Re: Oliver Shoemaker Drain, Prairie Lakes Arm

Re: Oliver Shoemaker: Prairie Lakes Arm

REGULATED DRAIN PLAN & PROFILE

PROJECT:
PRAIRIE LAKES APARTMENTS
 141ST STREET AND PRAIRIE LAKES BLVD.
 NOBLESVILLE, INDIANA

SHEET NO.
C4.17
 OF

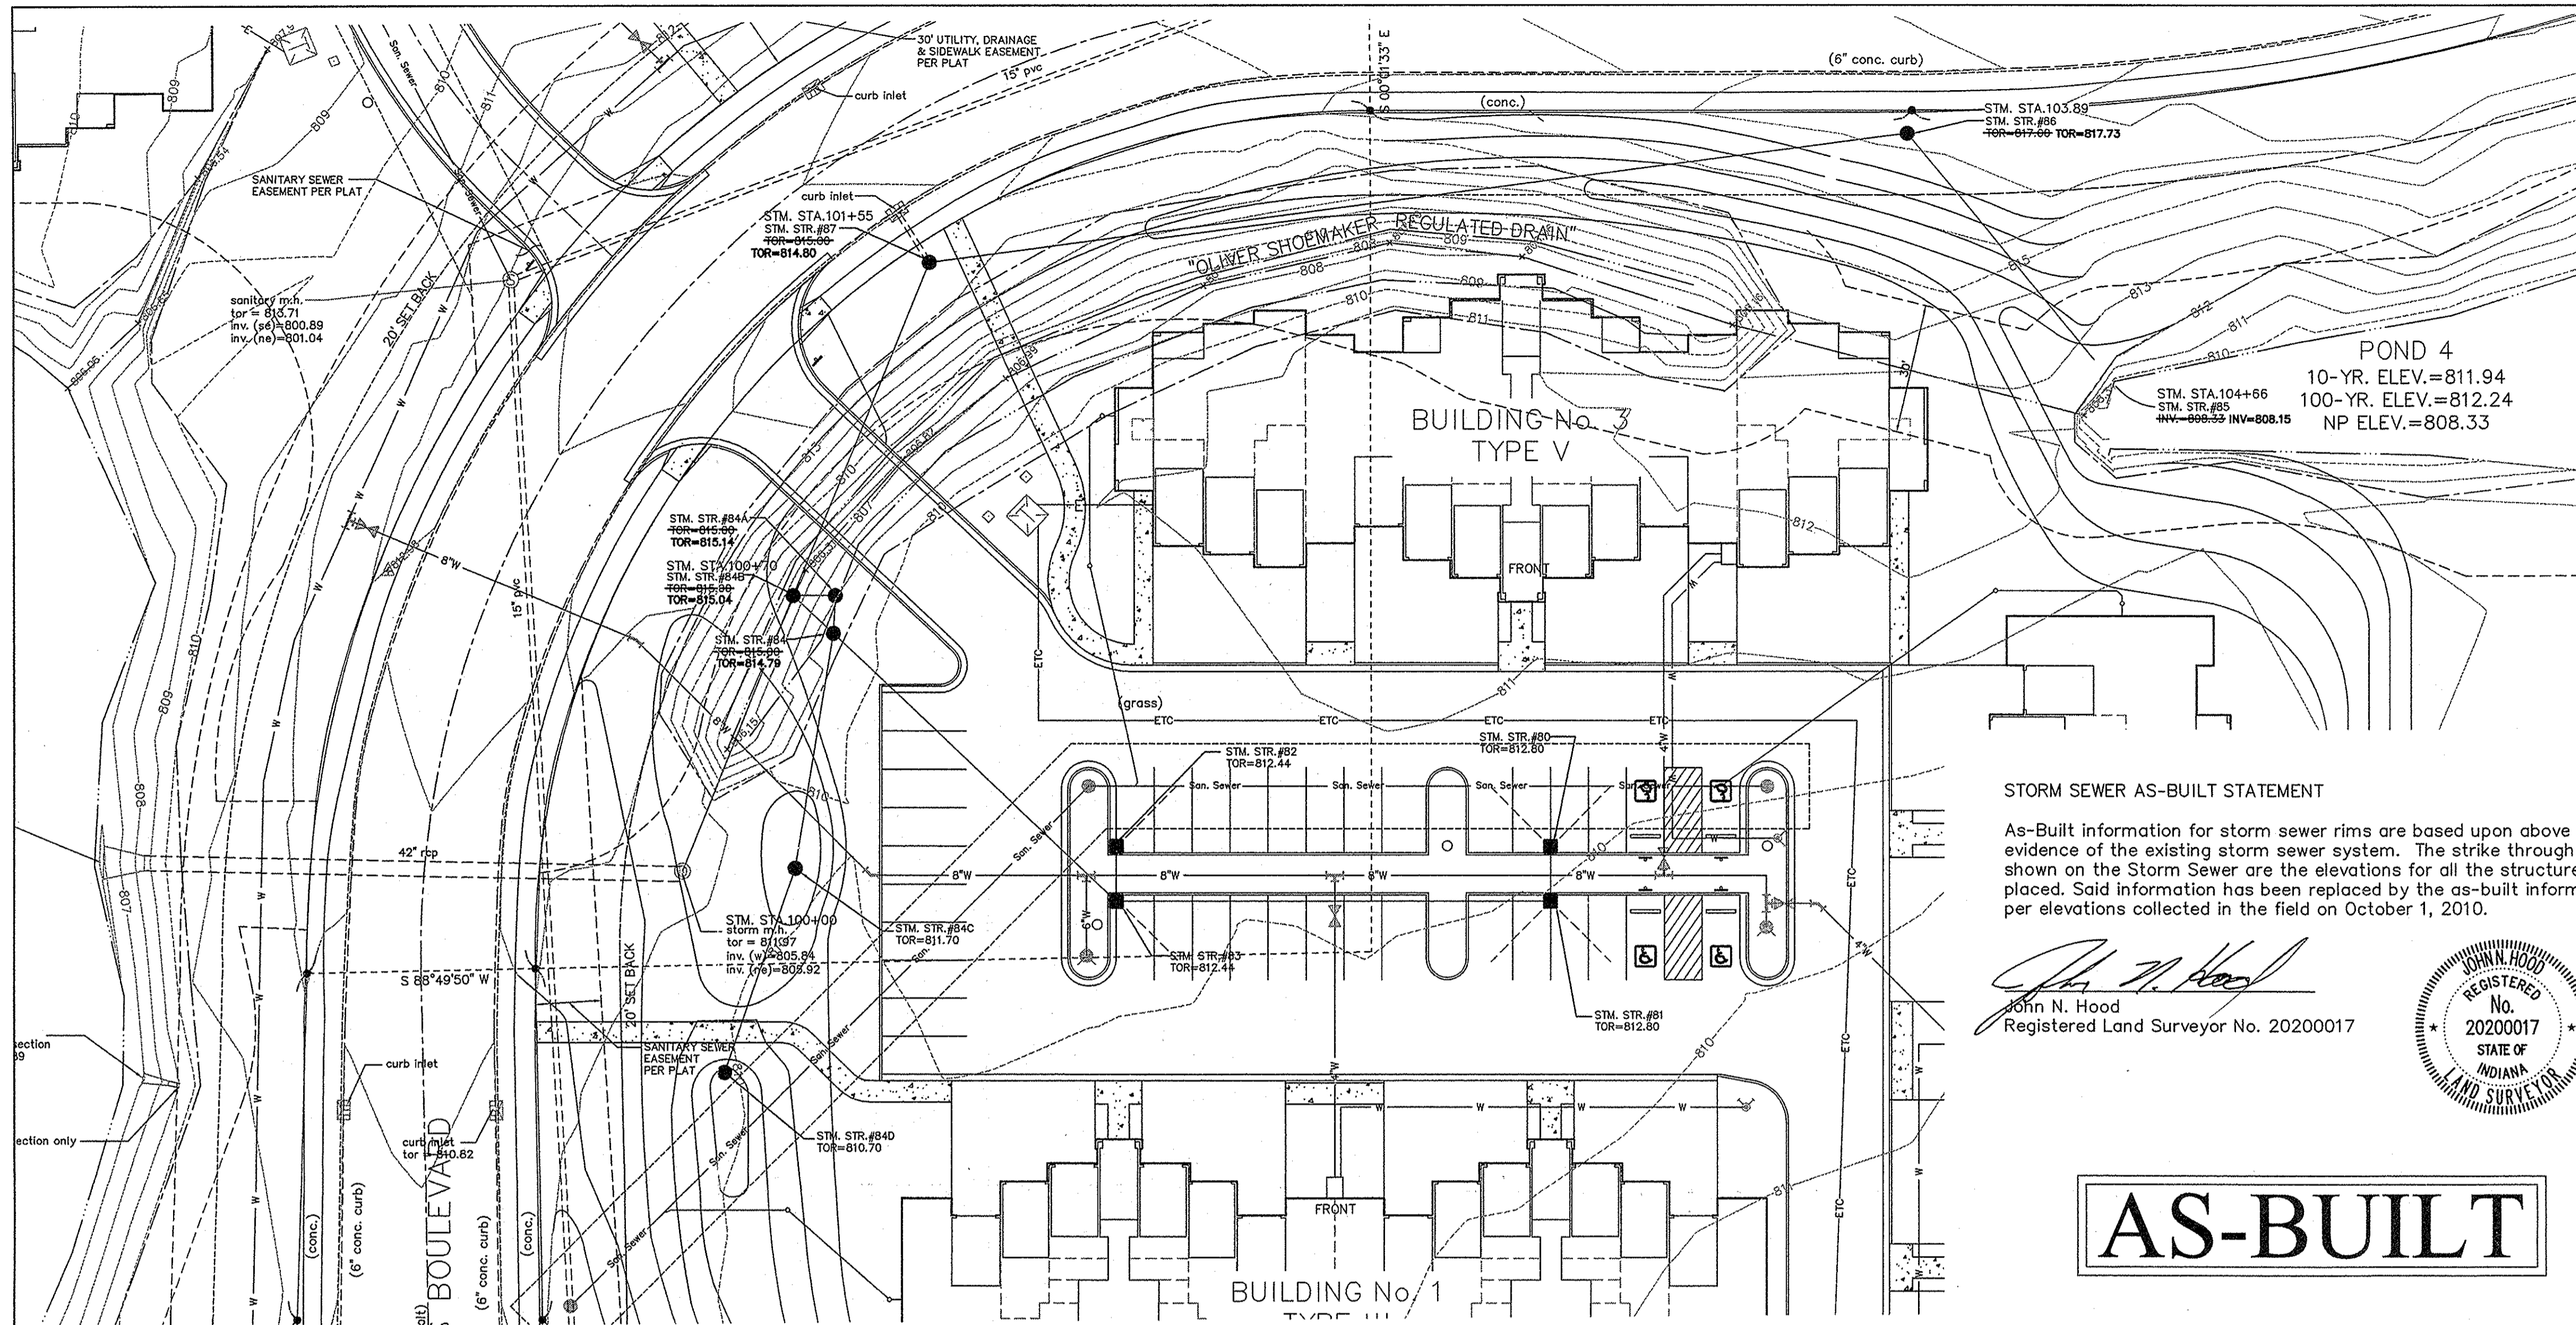
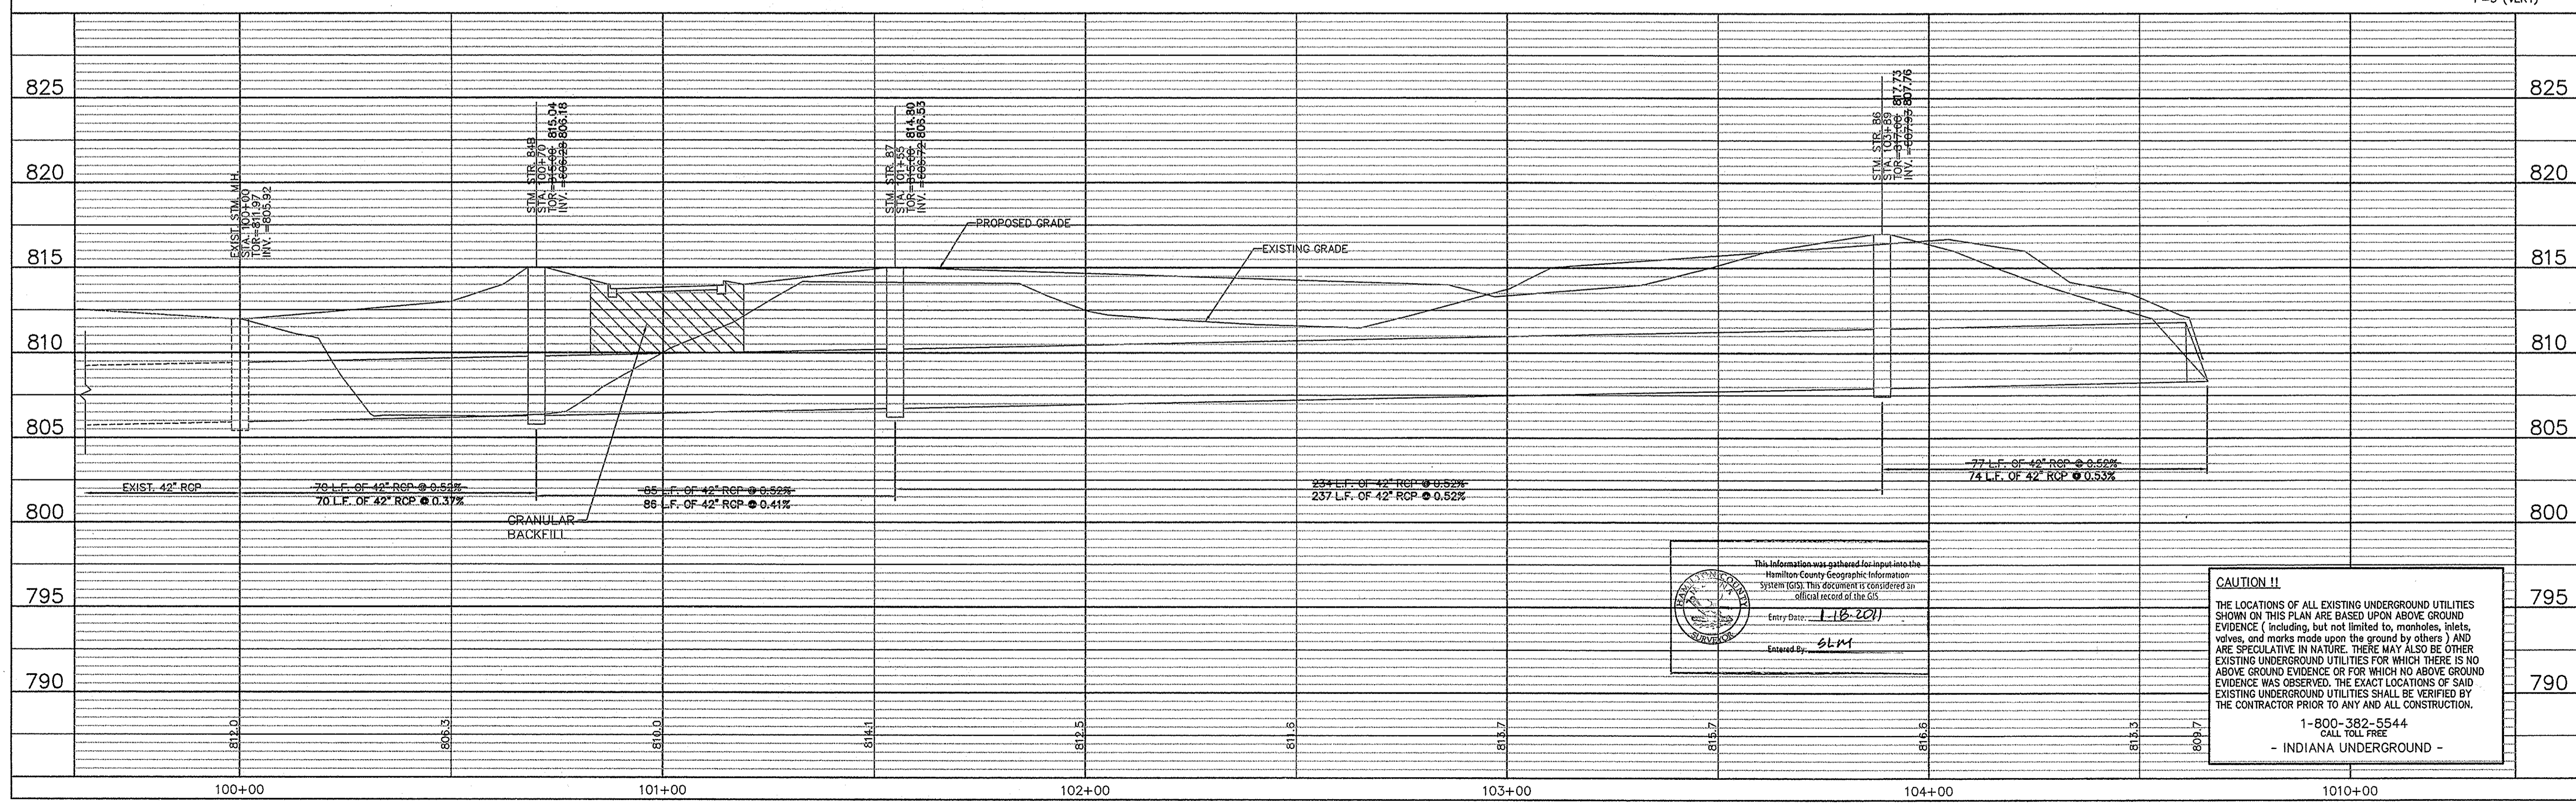
During construction, changes were made to the drain, which will alter the plans submitted with my report for this drain-dated July 23, 2008. The report was approved by the Board at the hearing held July 23, 2008. (See Drainage Board Minutes Book 11, Pages 236-237) The changes are as follows: The 42" RCP was lengthened from 466 feet to 467 feet. The length of the drain due to the changes described above is now **467 feet**.
